AGENDA Zoning Board of Appeals

TO: Village of Pewaukee Zoning Board of Appeals
FROM: Mark Lyons, Planning Consultant
RPT DATE: April 4, 2025
MTG DATE: April 11, 2025
RE: David Topp and Lisa Lesinski-Topp Variance Request

On February 17, 2025, the property owners submitted a Variance Application requesting a variance from Section 40.367.7 which requires a 20' rear yard offset, for the construction of a 13'x16' deck on the rear of home. The applicant is requesting to reduce the rear yard offset by 10' to allow for the construction of the proposed deck.

407 Riverside Drive
David and Lisa Topp
Deck Variance Request

MASTER PLAT

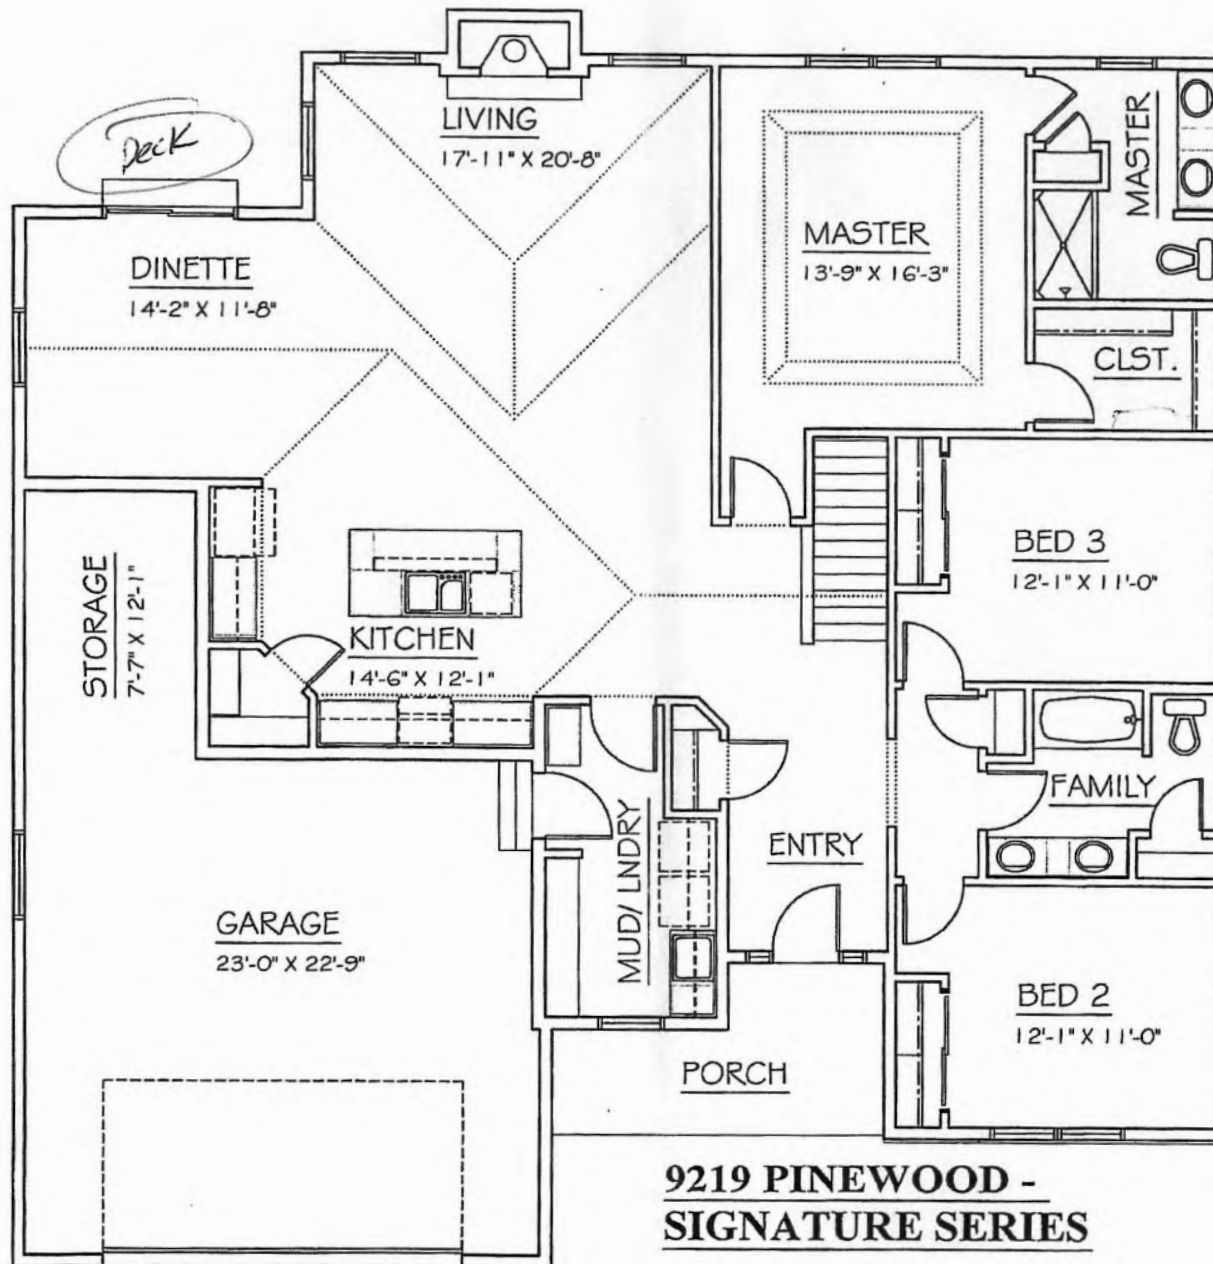
The subject parcel is consistent dimensionally with other parcels developed in the same subdivision and area and there are no easements or property obstacles restricting placement of a deck. The applicant may not meet the statutory requirements for a unique property limitation and instead may constitute a self-imposed hardship due to this being the applicant preferred location as opposed to the only viable location due to property limitation.

Staff has reviewed the Building Permit for a new deck at 407 Riverside Drive. Please be aware that this permit cannot be issued. The parcel is zoned R-5 with the Redevelopment overlay district, which requires a minimum rear offset of 20 feet (Code Sec. 40.367.7). This setback is not met.

Please submit revised plans in conformance with required setbacks.
